G.O. No.	816	Press
		Min.
Dated	24-12-33	18-52

No. 3. Read the following letter from Colonel C. E. FABER, Chief Engineer; to J. D. BOURDILLON, Esq., Secretary to Government, dated 23rd March 1859, No. 8923.

Letter from Captain JOHN MULLINS, District Engineer, Nellore; to Colonel C. E. FABER, Chief Engineer, dated Ongole, 7th March 1859, No. 454.

Summary of Works performed at the Pennair Annicut in 1858, No. 28.

Section A.

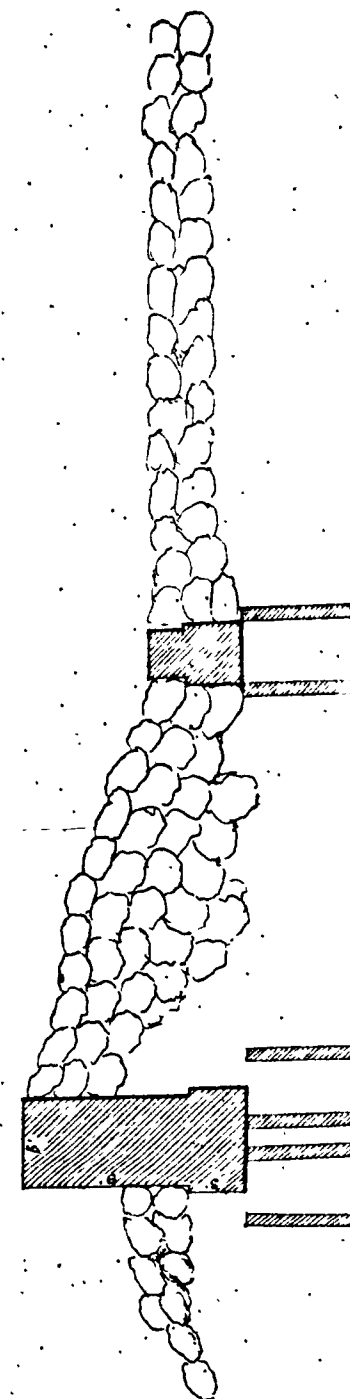
2. The section for the work as first proposed is shewn in the enclosed Plan marked A, this was not approved of by the Revenue Board who forwarded, in December† 1853, the revised Section marked B for the consideration and report of the then Acting Civil Engineer of the 2nd Division, who considering that a Bridge which was combined with the rejected Section, would endanger the safety of the work, recommended the adoption of the Board's arrangement, and accordingly the execution of the work on the latter plan was ordered to be carried out in February‡ 1854.

Section B.

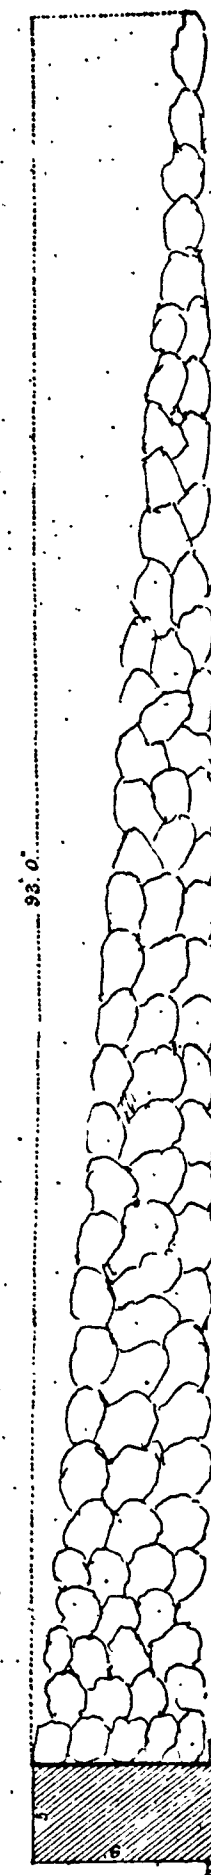
2. As Government is in possession of the views of Colonel A. T. Cotton, it is needless for me to say more than that I believe the failure of the Annicut may be attributed, first to far too slight a Section having been adopted; and secondly, to insufficiently massive materials having been used in its construction.

Section D.

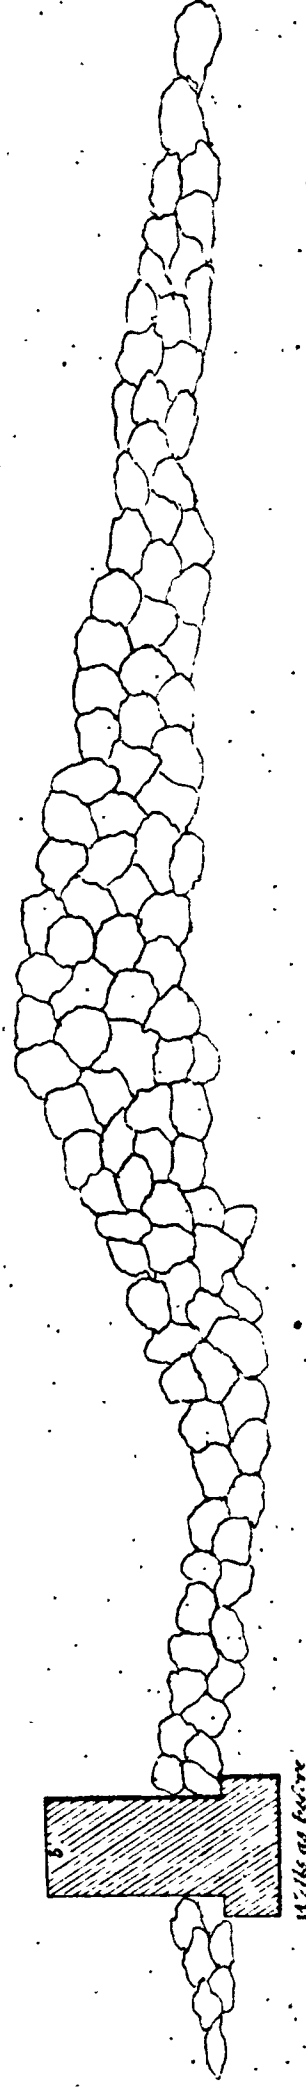
4. The masonry work was very well executed in laterite stone, and the under Sluices were most excellent specimens of work in this material, and stood many freshes without injury, but the freshes at the end of 1855, which however never rose to a greater height than 9 feet above the crown of the work, showed that the rough stone Apron was not capable of resisting the action of the water. The effect of these freshes is shown in the Section marked D, and it seems highly probable that had stone of proper size been brought from the quarries by a Railway, instead of the small¶ sizes which alone could be conveyed by bandies, very small modifications of the Section would have sufficed to render the Annicut permanently stable.

5. These freshes of 1855 showed that some improvement was necessary to prevent the disturbance of the Apron for the future, and in December 1855, the Civil Engineer was directed* to construct a rough stone retaining wall in the Apron at a distance of 30 feet from the front wall, and to cover the surface of the rough stone between the two walls with a layer of jelly 3 inches thick. This arrangement was completed in 1856, at a cost of Rupees 2,812-7-0, and is shewn in the Section marked E.

Section F.

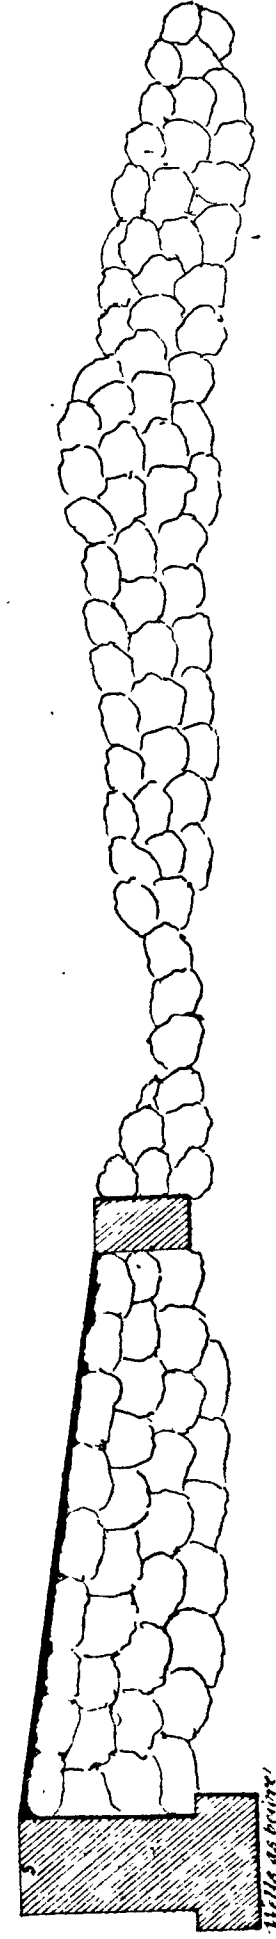
6. On the recurrence of freshes in July 1856, it was found that the upper part of the work had been secured by the additions just described, but that the water worked out the rough stone immediately below the retaining wall, producing an exactly similar effect to that originally experienced, but at a different part of the work. This result is shewn in the Section marked F.

7. To obviate this source of injury, after some discussion,† the arrangement shewn in the Section marked G was, in the last communication marginally noted, ordered to be carried out. As will be seen from the Extract|| from the river register shewn in the margin, the river was frequently in flood between the 1st August and the end of the year, but the damage was comparatively speaking slight, and the cost of the repairs was but little. The arrangements shewn in Section G were completed early in 1857, and no accident happened afterwards to the Annicut until November 1857, when the river rose to 11 feet above the crown or 20 feet above the floor of the under Sluices on the 21st of that month and a breach of 102* yards occurred a little to the north of the centre Sluices. Besides this damage the lowest retaining wall, all the rough stone† beyond it, and most of the small Apron above it were carried away, but the upper retaining wall and the Annicut above it were, except at the breach, left quite uninjured.

Section H.

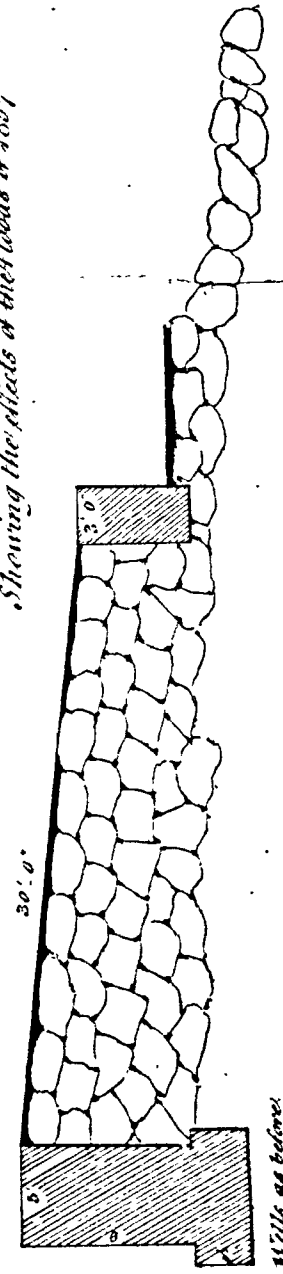
8. This fresh was one of unusual height and there is but little doubt that had it lasted for a few days longer at a depth on the crown of 5 to 7 feet, the damage would have been much more extensive. It was evident that the rough stone was quite unable to withstand the force of the water, and this, the protecting material for the masonry walls having been removed, the destruction of the latter bit by bit was merely a work of time. Here again had massive blocks of stone formed the lowest Apron, very little if any damage would have resulted, but there being no means of transporting such stone to the work, it was obliged to rely on the material that was available.

Section K.

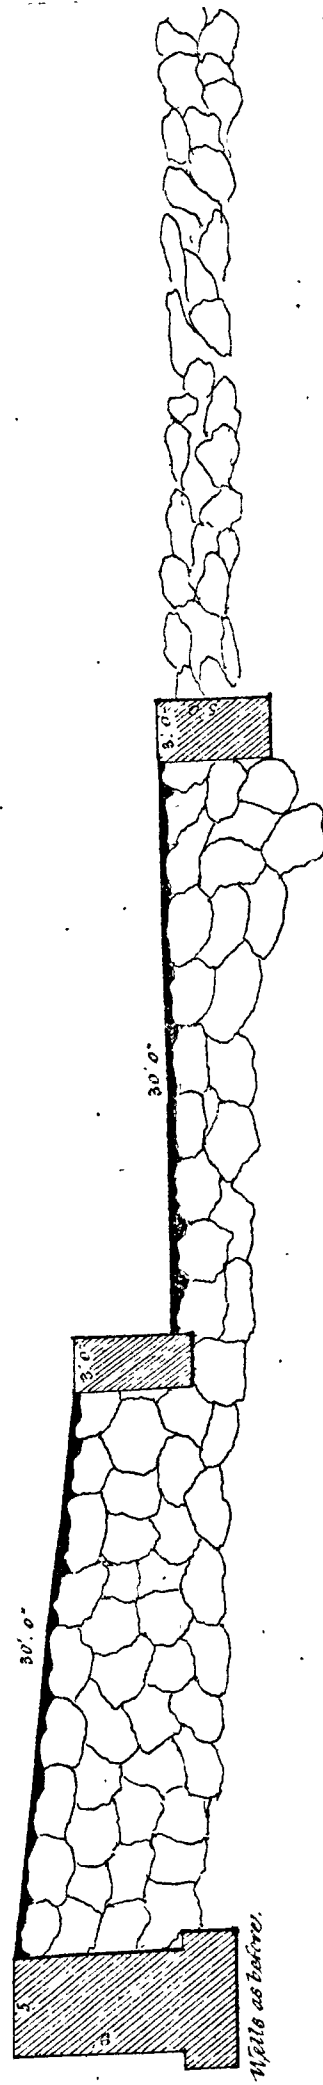
9. The frequent failure of the work and the great and continual expense of keeping it efficient having rendered it necessary that considerable alterations should be made, and an arrangement shown in the Section marked K, which was submitted in November 1857, not having been altogether approved of, while opinions among those qualified from experience to judge, differed as to the best form to adopt in the then existing state of the work, the Superintending Engineer of the Southern Circle was authorized to pay a visit to the Annicut and to decide on the best Section to be given in restoring it to an efficient and permanently stable condition, and after making the necessary investigation, that Officer adopted the arrangement shewn in the Section marked L, which, together with a Railway from the Quarries, was approved of and sanctioned in Extract Minutes Consultation No. 305, dated 22nd February 1858.

Section L.

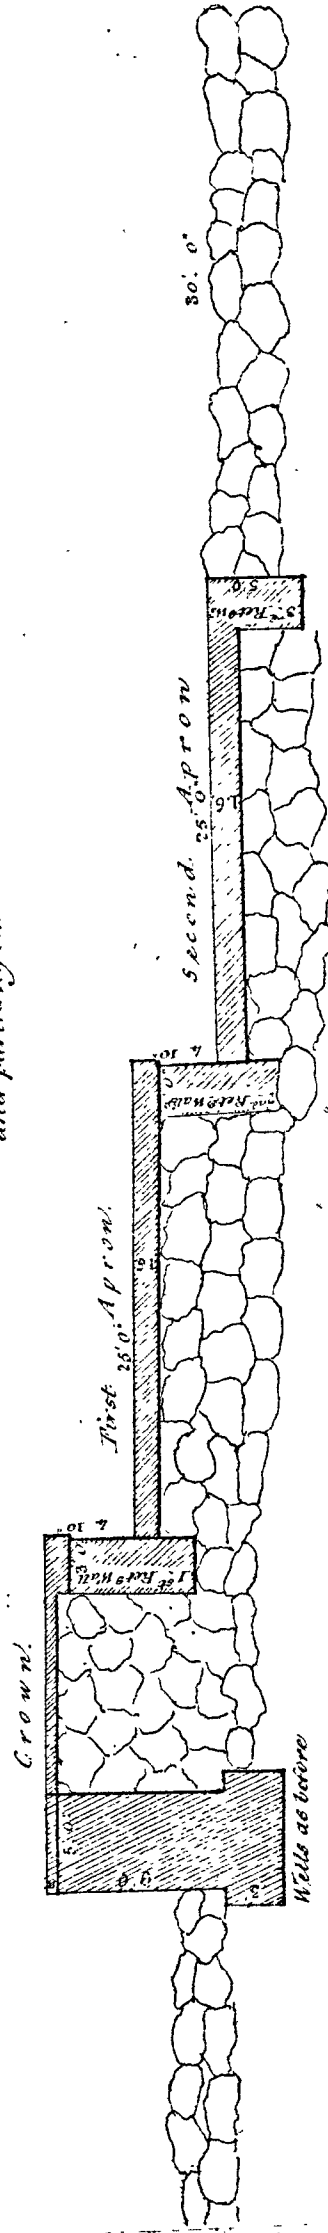
19. The Section adopted* would, I believe it completed and allowed time to dry, have stood even with such a flood as that experienced this last mon-

parts, still the diagrams were taken at the South end, and it is certain therefore, that the trial was sufficiently severe to test the strength of the work. Taking however the character of the River into account, it may well be worthy of consideration, whether any Section requiring such a state of entire completeness to ensure its stability, is looking to the future, adapted for the Annicut at Nellore; for letting alone the interruptions to the work in progress, which must be frequent, and might occur so often as to render completion in one season impossible, it would seem necessary, in order to prevent the chance of any part becoming uncovered, and thus proving the commencement of extensive damage, to provide for a large surplus of strength both in the Aprons and retaining walls, and this would make the Section a particularly expensive one, from the amount of masonry work it would require, and a particularly difficult one, from the necessity of collecting a very large amount of skilled labour.

Plan M.

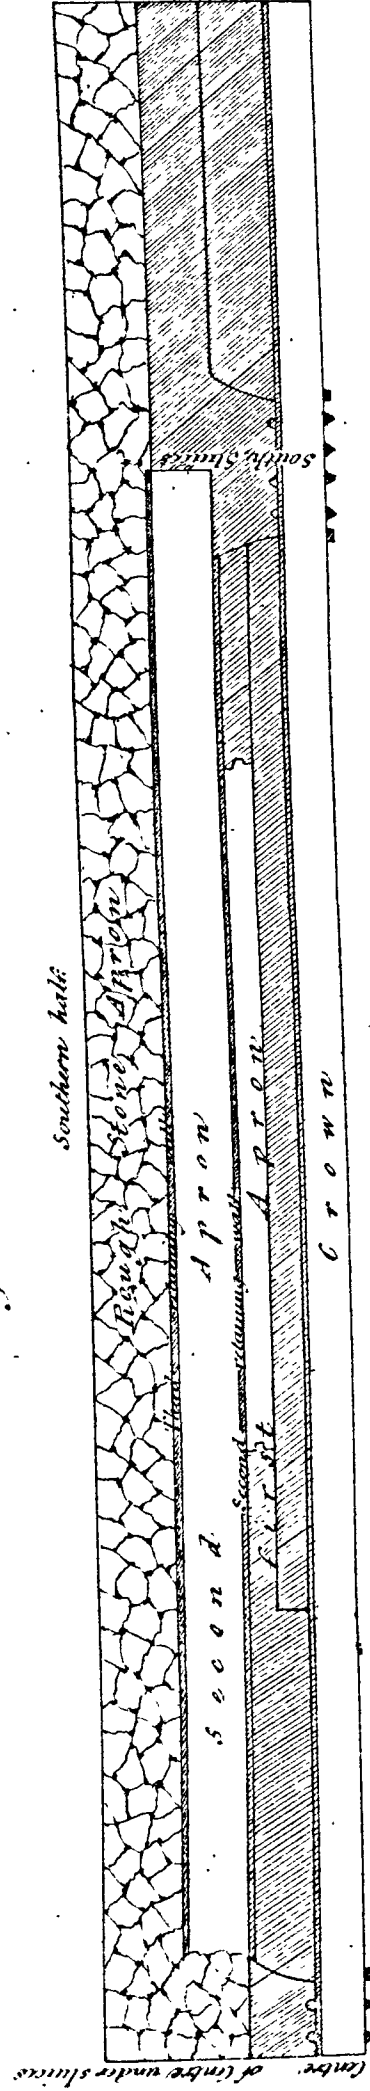
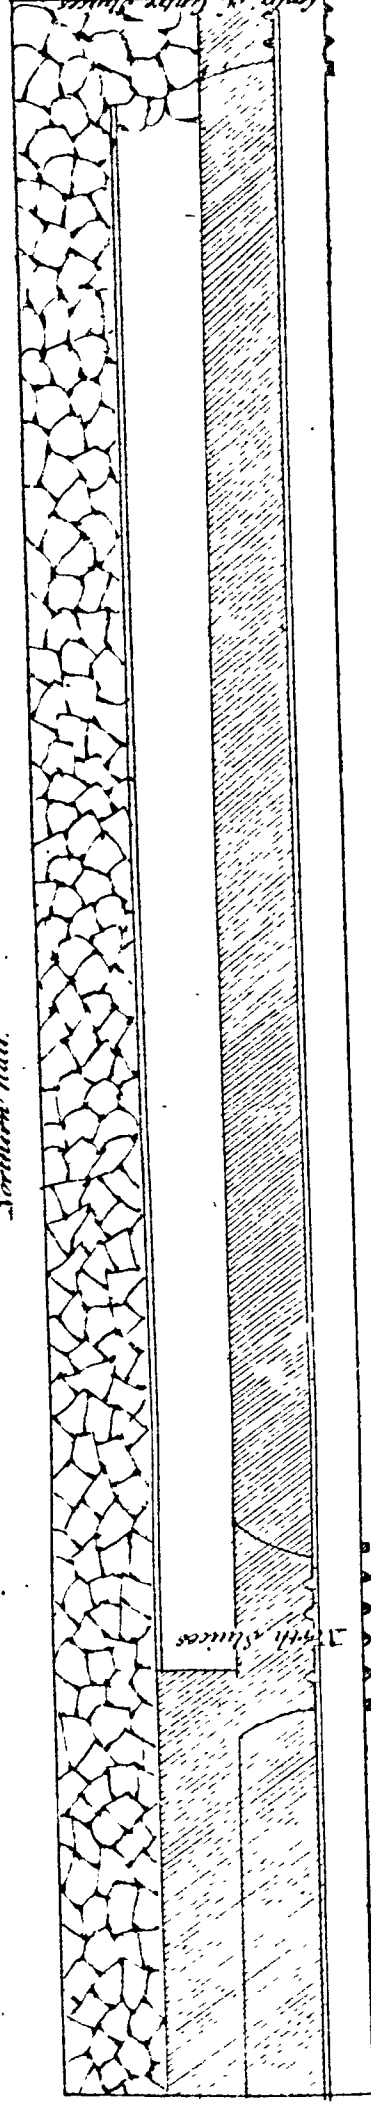
but on the 7th of September the river commenced rising* and on the 8th, 5 feet of water were flowing over the crown of the work. The results of the fresh, which was occasioned by the heavy rains falling on the western portions of the extensive basin† south west monsoon, were particularly unfortunate, as not only was the work stopped at this critical period for a fortnight, but in addition to the extensive damage* done to newly completed parts of the Aprons and retaining walls, the level of the river was afterwards never low enough to admit of the 2nd or lowest cut stone Apron being gone on with, and it became necessary to endeavour to secure the 1st Apron and its retaining wall with rough stone. To accomplish this the people of the villages under the Annicut Channels were called upon to subscribe labour and for a few days about 800 coolies were, in addition to the usual supply kept at work and no portion of the 2nd wall was left unsupported. The repairs of the retaining walls and of the 2nd Apron was pushed on with the greatest possible rapidity, and at the commencement of October not more than a week was required to complete all that could be done that year, with the exception of continuing to strengthen up to the last moment the lowest portion of the work with rough stone.

Plan O.

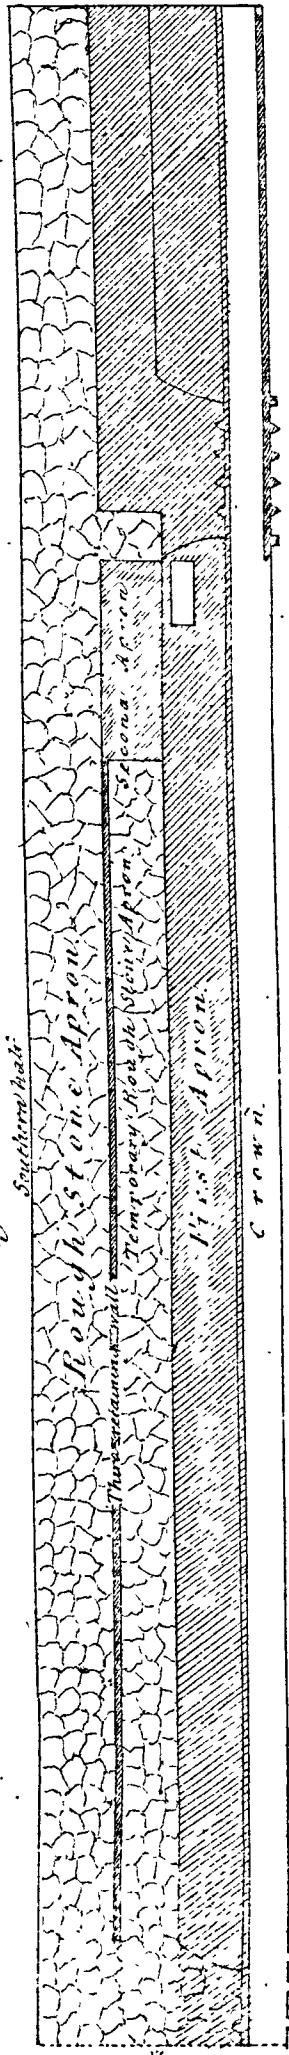
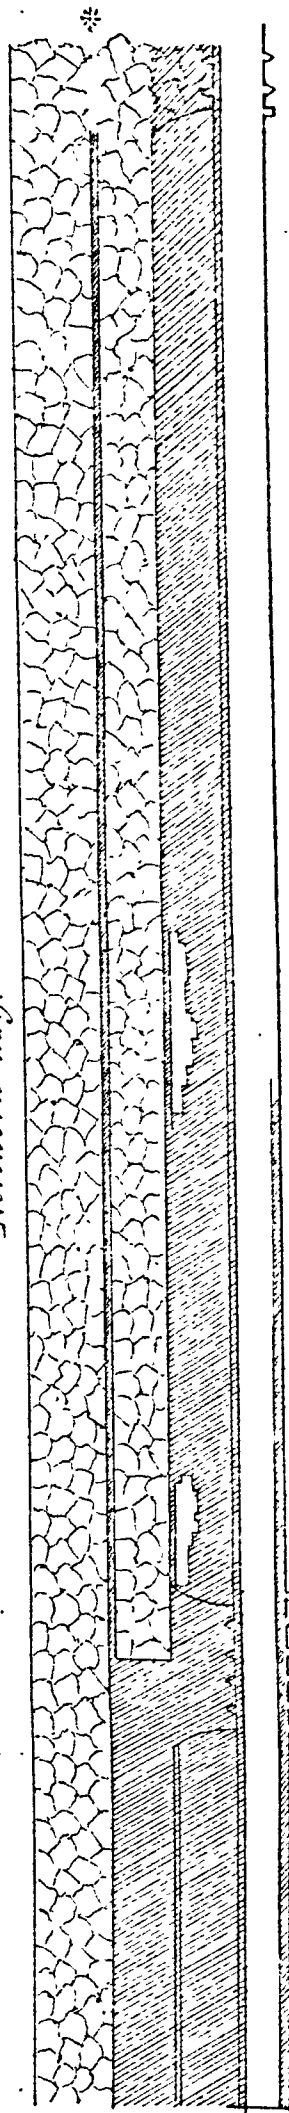
16. Such was the condition* of the Annicut, when on the night of the 8th and 9th Oc-

Plan P.

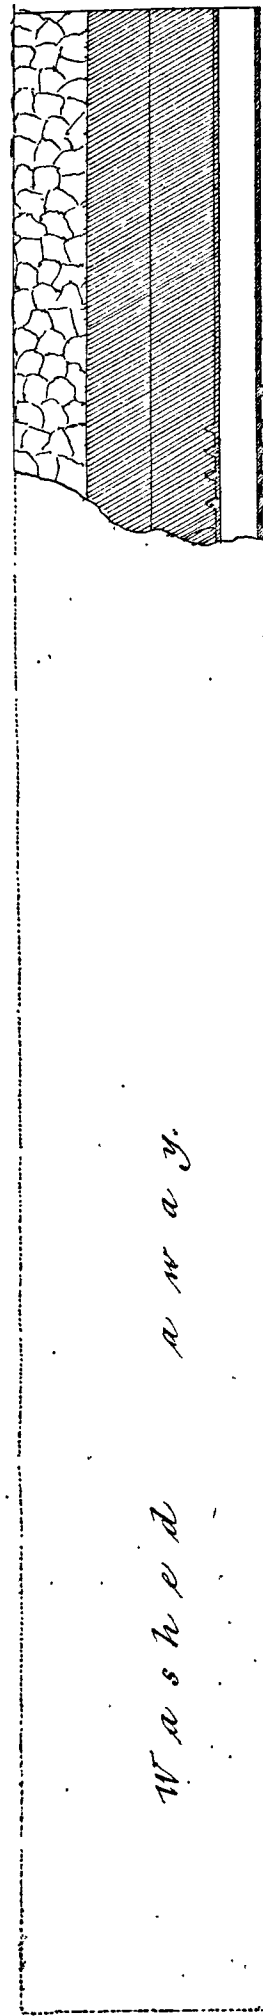
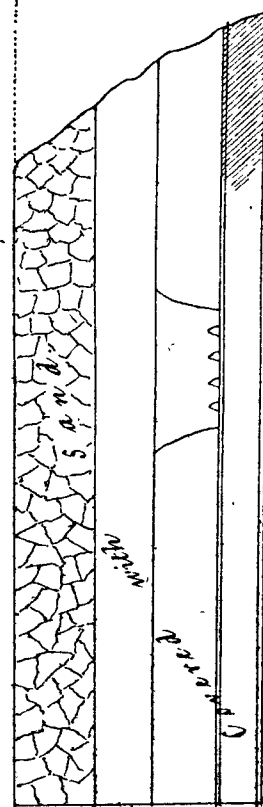
have been already detailed in the letters as per margin.* I regret that not having a copy of the sketch of the appearance of the overfall which was submitted with the first named letter, I have been unable to add it to the other Plans and Sections, but should you consider advisable, perhaps you will allow a copy to be added in the Central Office. The effect of the flood may be summed up in a few words. Two-thirds of the Annicut were swept away by it, and to this nothing

18. As regards the cause of the damage amounting to the almost entire ruin of the work, there can be no doubt that its unfinished state was the reason why it fell so easy a prey under the force of the water; still looking at its condition a day or two before the flood, i. e., at the beginning of October, I think it may fairly be supposed, that an ordinary monsoon fresh would not have caused any damage of moment; for the 1st Apron was all but complete, a small portion of the 2nd Apron was finished, the whole of the 3rd retaining wall had been put down many weeks before, and the site of the unfinished 2nd Apron was covered into more than a yard in depth with rough stone, in order to support the 2nd retaining wall. The character of the flood was however, if the usually received theory of the amount of obstruction offered by Dams across Rivers be correct, a very exceptional one. From the observations contained in para. 7 of my letter No. 2745 of the 11th December, it will be seen that the level of the flood waters was raised not far short of 5 feet by the obstruction caused by the Annicut, while the theoretical increase of elevation does not exceed 2 feet. On the other hand, as will be seen by the diagrams referred to at the commencement of para. 17 of this letter, the difference of level between the
